August 2018
SF542A-Y
REVISED NOTICE

Subject: New Cascadia Retrofit

**Models Affected: Specific Freightliner Pre-series Cascadia models
manufactured June 13, 2016, through February 13, 2017.**

Fig. 1, sSAM Ground Locations

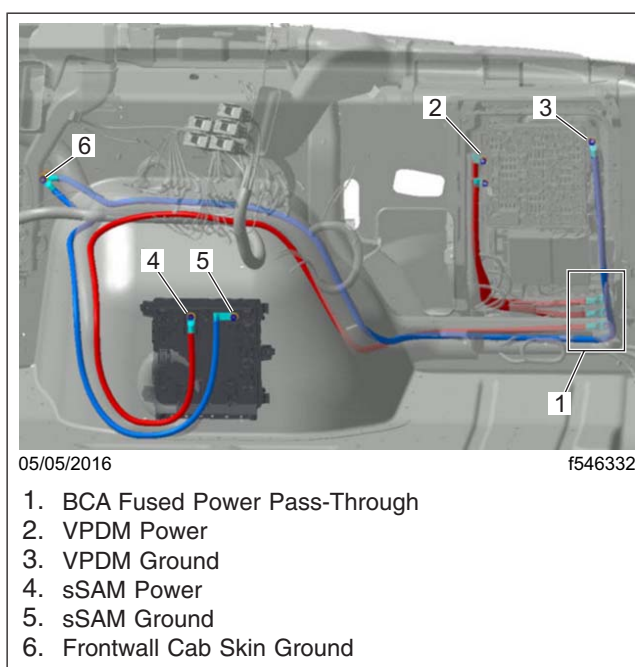
1. Park the vehicle on a level surface, shut down the engine, and apply the parking brakes. Chock the tires.
2. Disconnect the batteries.
3. Remove the dash lower center console, the dash top cover, the footwell panel, and the dash switch panel. Refer to Section 60.06, Subject 100 in the *New Cascadia Workshop Manual* for instructions.
4. Open the vehicle power distribution module (VPDM) cover.
5. Check the torque at the single SAM (sSAM) ground. See [Fig. 1](#). Loosen the nut and torque to 9 lbf·ft (12 N·m).

6. Remove the HVAC ducting that sits in front of the ground stud, then remove the stud-mounted cable tie. Refer to Cab Heater and Air Conditioner in the *New Cascadia Workshop Manual* for instructions.
7. Check the torque at the frontwall cab skin ground, The torque should be 7.3 lbf·ft (10 N·m). Loosen the nut and torque, if necessary.
8. Install the stud-mounted cable tie.
9. Install the HVAC ducting.

Fig. 2, Virtual Technician and Common Telematics Platform in the Electronics Bay

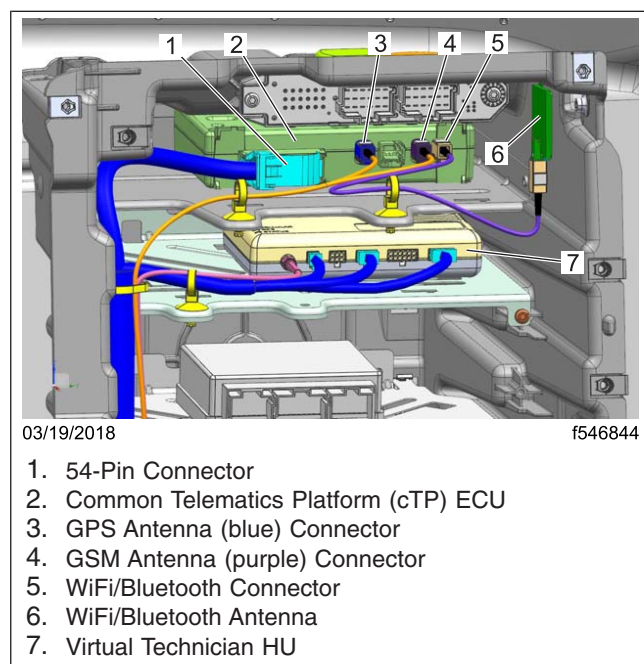
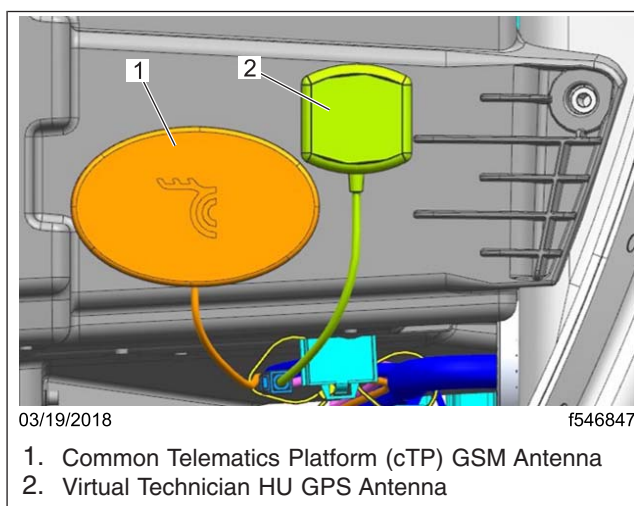
1. Remove the VPDM from the electronics bay. Refer to Section 54.08, Subject 100 in the *New Cascadia Workshop Manual* for instructions.
2. Check to see if the Virtual Technician HU (VTHU) is still installed. See **Fig. 2**. If the VTHU has been removed, verify that the VTHU connector is capped and secured. No further action is necessary. Continue with the next procedure listed for the vehicle.

3. Disconnect the VTHU harness connectors.
4. Remove the VTHU, and discard.
5. Remove the VTHU GPS antenna from the top of the electronics bay, and discard. See **Fig. 3**.

6. Cap the VTHU connector and antenna connector with heat shrink tubing, and secure it against the main harness bundle.
7. Label the VTHU harness.

Fig. 2, Virtual Technician and Common Telematics Platform in the Electronics Bay

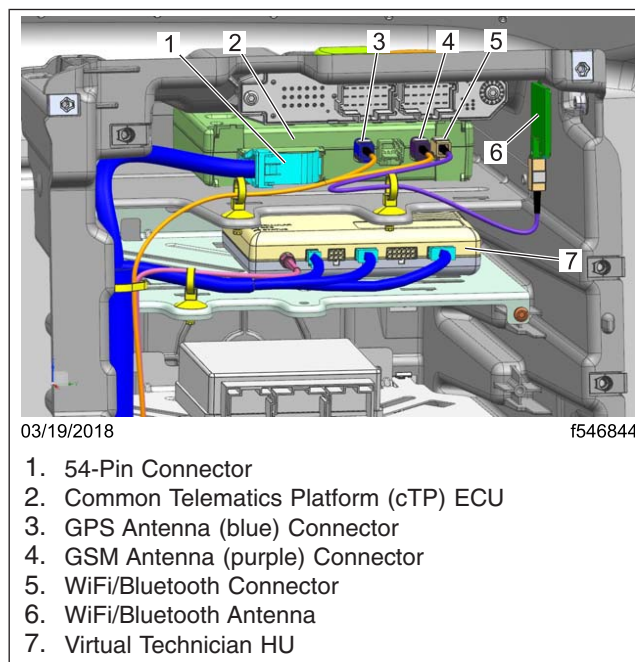
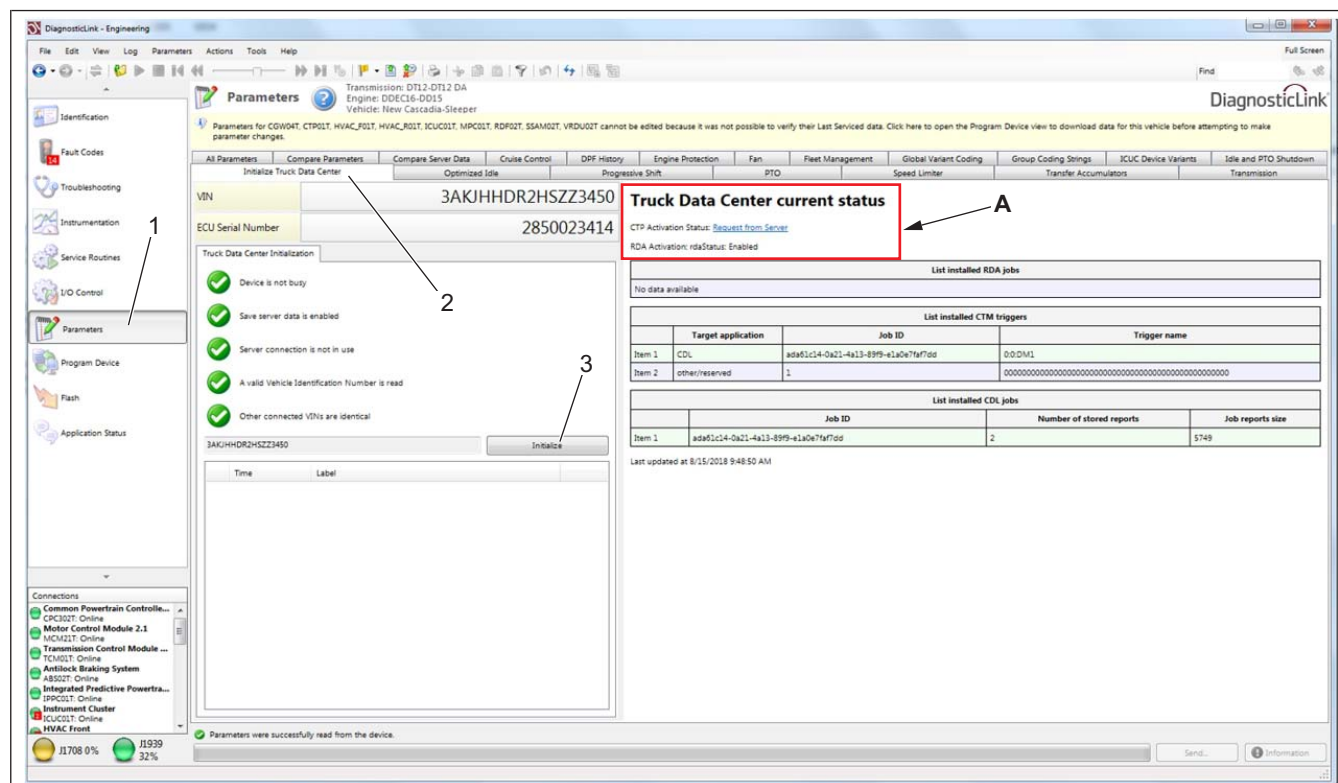
1. Disconnect the 54-pin connector, the GPS antenna connector, the GSM antenna connector, and the WiFi/Bluetooth antenna connector from the cTP. See [Fig. 2](#).

2. Remove the common telematics platform (cTP) ECU from the electronics bay by pressing the cTP ECU firmly towards the back of the electronics bay to release the ECU from the forward mounting slots. Lift the ECU and pull it out of the bay.

3. Check the part number on the cTP ECU. If the part number is **NOT** 66-05466-001, install the new cTP ECU with part number 66-05466-001 supplied in the kit.
If the part number is 66-05466-001, continue with step 4.

4. Check the inside wall of the electronics bay. If an antenna is installed, go to step 6.
If no WiFi/Bluetooth antenna is installed, continue with step 5.

5. Remove the peel strip from the adhesive backing on the antenna, and adhere it to the inside wall of the electronics bay, near the cTP.
6. Position the cTP ECU in the electronics bay, then press the ECU firmly towards the back of the shelf. Lower the front of the ECU on to the surface of the shelf and adjust its position horizontally until the tabs on the ECU are fully seated in the mounting slots.

7. Connect the antenna to the cTP, and all other connections that were removed earlier. See [Fig. 2](#).
8. Initialize the cTP.
 - 8.1 Connect the vehicle to DiagnosticLink. Click on "Parameters" then select the "Initialize Truck Data Center" tab. Run the initialization procedure by clicking on the "Initialize" button. See [Fig. 4](#).

Fig. 5, Dash Pressure Switch Connector

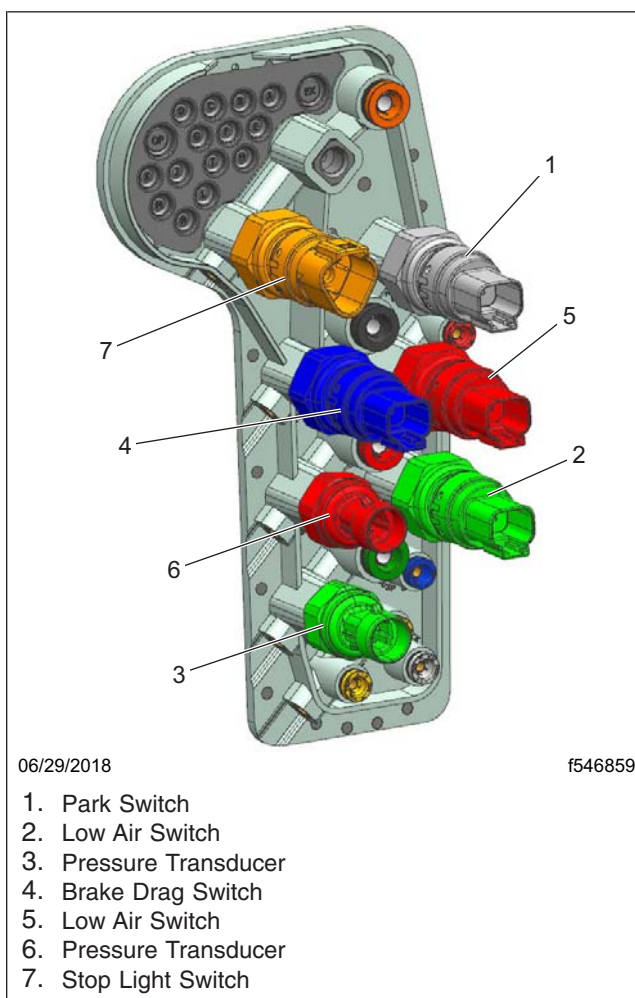
1. Remove the lower dash panels and the steering wheel column on the driver side of the vehicle. Refer to Section 60.06, Subject 100 in the *New Cascadia Workshop Manual* for instructions.
2. Remove the throttle pedal cover.
3. Remove the air pressure switch. See [Fig. 5](#), ref. 1.

4. Install the switch supplied in the kit.
5. Connect the switch connector to the air pressure switch.
6. Using the three screws, install the throttle pedal cover.
7. Install the dash panels and the throttle pedal cover.

Fig. 6, ITOC Assembly

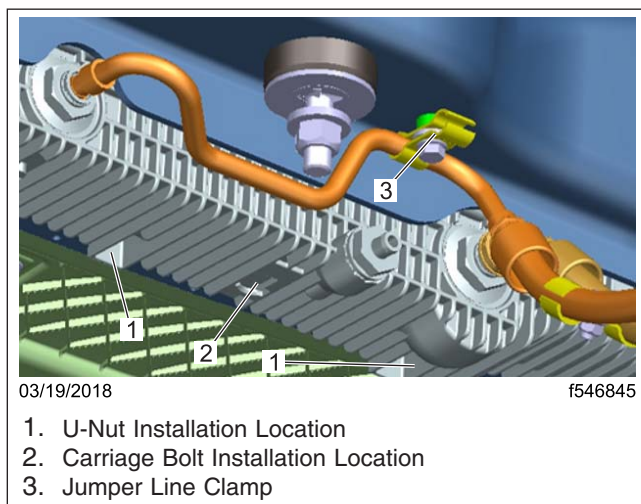
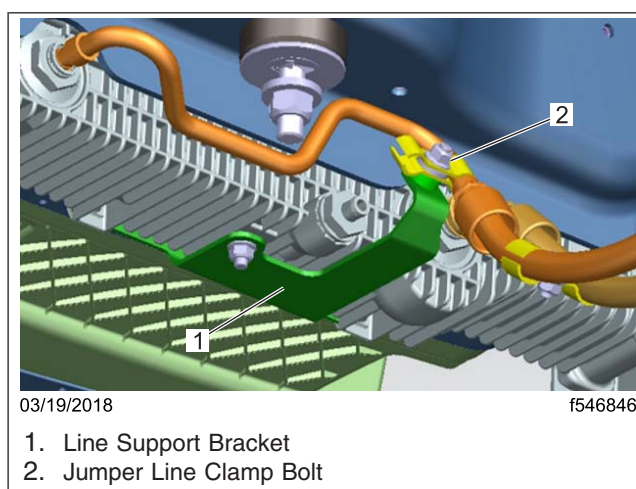
1. Remove the jumper line clamp bolt, and save the clamp and spacers.
2. Install the new U-nuts and carriage bolt supplied in the kit in the lower radiator tank. See [Fig. 6](#).
3. Loosely install the new line support bracket.
4. Install the jumper line clamps, spacers, and nuts and finger tighten. See [Fig. 7](#).
5. Tighten the carriage bolt, front bracket bolts, and line clamp nut to 11 lbf-ft (15 N·m).

Fig. 8, Brake Valve Mounting

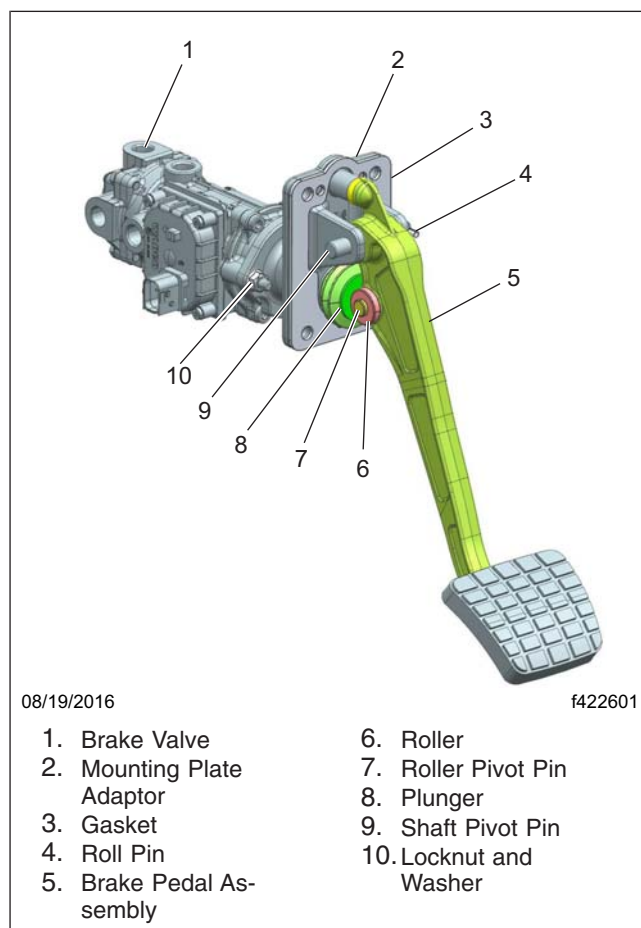
Figure 8 shows the brake valve mounting.

1. Open the hood.
2. Check the torque on the four mounting bolts. The torque should be 14 to 17 lbf-ft (19 to 23 N-m). Adjust the torque as necessary.
